Previous Recall 0516J – Fuel Leak at Fuel Pump Rings:

(Note: Recall 1017E replaces previous recall 0516J)

Recall 1017E – Fuel Leak at Fuel Pump Discharge Pipe:

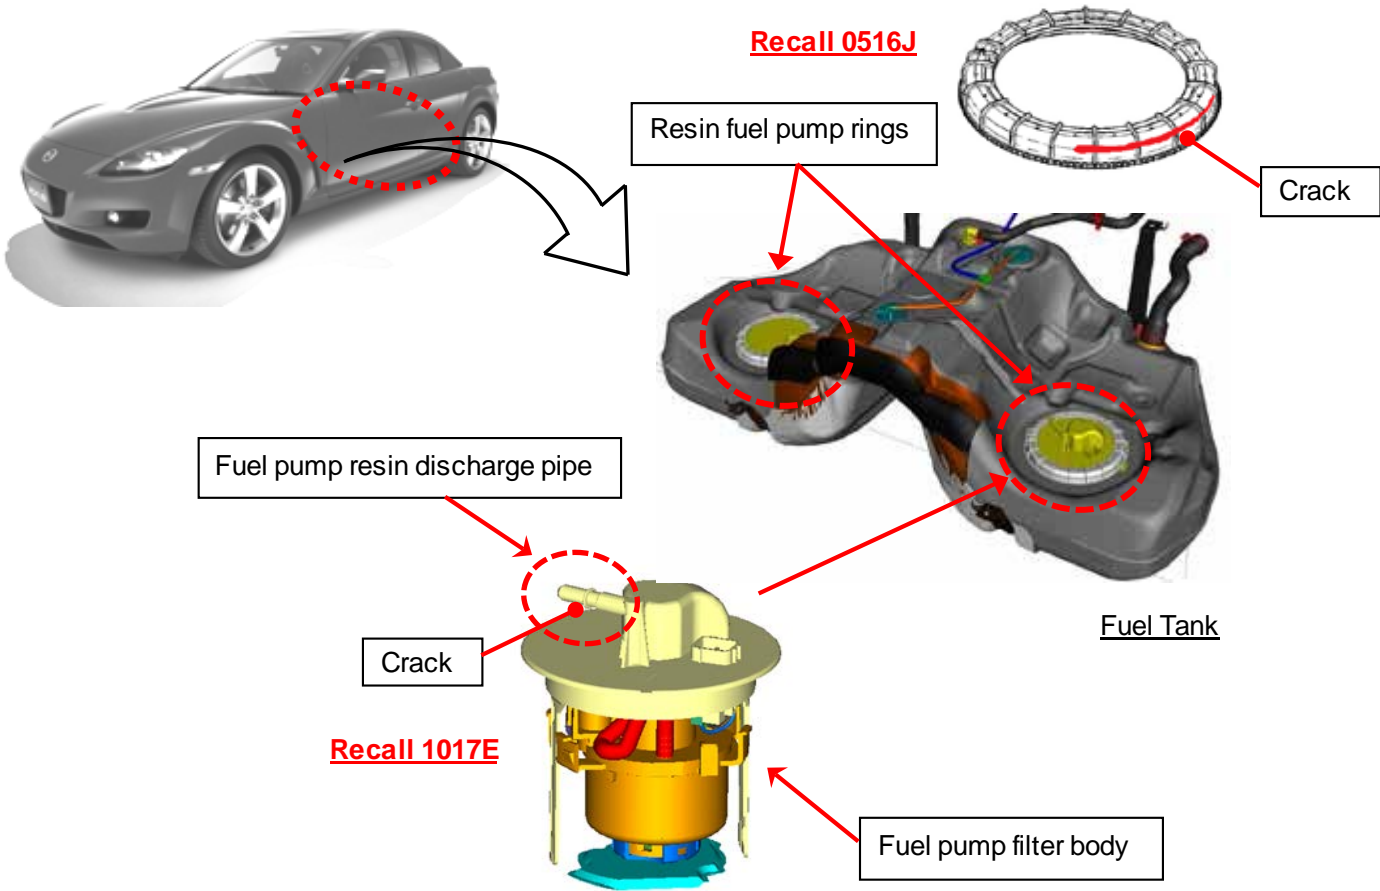
Due to insufficient durability of the resin discharge pipe of fuel pump, the discharge pipe may deteriorate, affected by the pressure of fuel inside the pipe and by heat from the engine and exhaust pipe. Continuous use of the vehicle may allow the deterioration of discharge pipe to progress, leading to a crack in the discharge pipe and subsequent fuel leak, which may increase a risk of fire.
